0050104 SCOPE of WORK COMMENTS FROM INTERNAL/INDUSTRY REVIEW

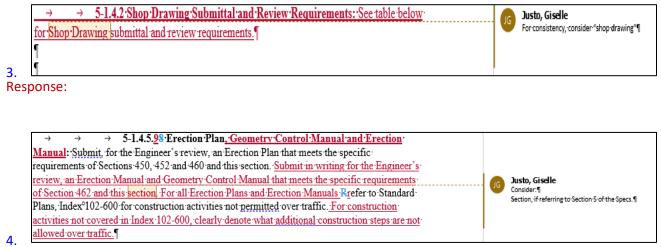
)	\rightarrow	\rightarrow	4. Detailer: The steel detailer that prepares the steel shop drawings for the		Justo, Giselle
f	fabrication, geometry and fit-up for all steel members in accordance with the plans ¶					This should be "Plans" if referring to the defined term in
Ŀ	\	75 Televiside Assistance and the control of the control of the				Division-I-of-the-Specs.¶
